# UNITED STATES PATENT AND TRADEMARK OFFICE

APPLICATION NO.	FILING DATE	FIRST NAMED INVENTOR	ATTORNEY DOCKET NO.	CONFIRMATION NO.
09/531,735	03/21/2000	Shalom Levin	EPLC/03	7129

**Office Action Summary**

## DETAILED ACTION

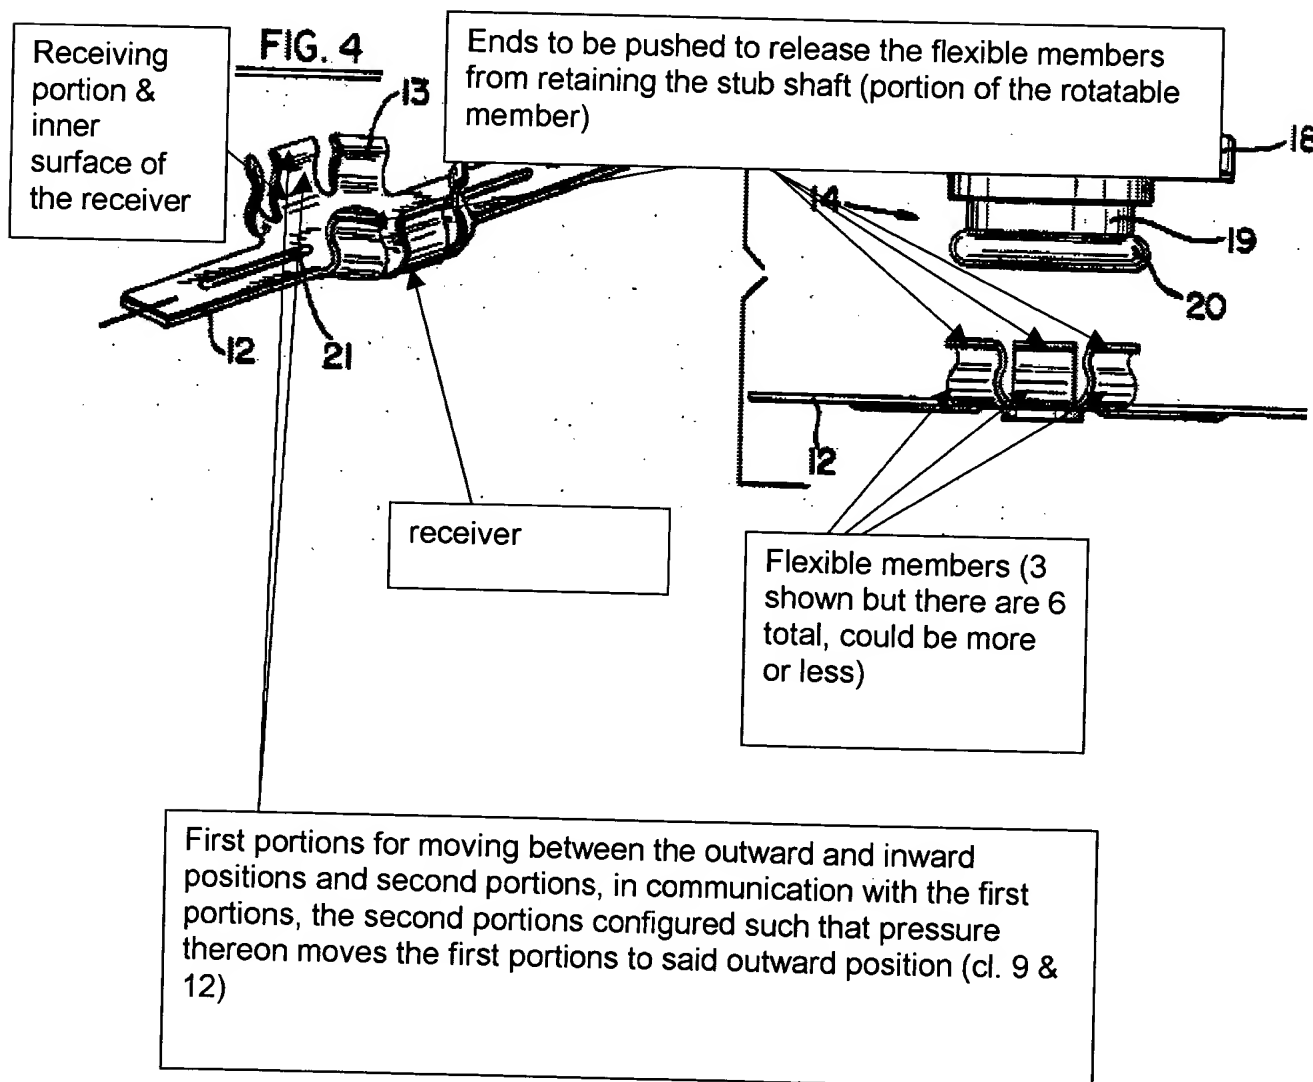
In re independent claims 9 & 12, Weber discloses as also shown in the marked up figures below, a lawnmower blade assembly comprising:

in re independent claim 12, Weber discloses a lawnmower blade assembly comprising:

- a shaft (15) rotatable with a motor (10);

- a stub (19, 20) in communication with the shaft (fig 2);

- a blade body (12) including oppositely disposed cutting portions (fig 6, blade 12 having oppositely disposed cutting portions) and a platform intermediate the cutting portions (as best shown on fig 4, the receiver is placed between the oppositely disposed cutting portions or in the middle of ref 12);

- a receiver (22) coupled coaxially to the blade (fig 4, 5), the receiver including a receiving portion (13) and at least a plurality of flexible members (13) configured for moving between outward and inward positions for engaging and retaining the stub in the receiving portion (fig 2) in a releasable engagement, the flexible members including ends configured such that pressure thereon moves the flexible members outward, allowing for at least the disengagement of the blade from the stub (as the top ends of flexible members of the receiving portion is moved outwardly the receiver is released from the stub shaft);

In response to Applicant's argument that Weber does not have "ends or second portions" (the first and second portions were added with the 8/20/03 amendment), is not agreed with, for demonstration purposes the Examiner provided a marked up drawings showing the first & second portions above.
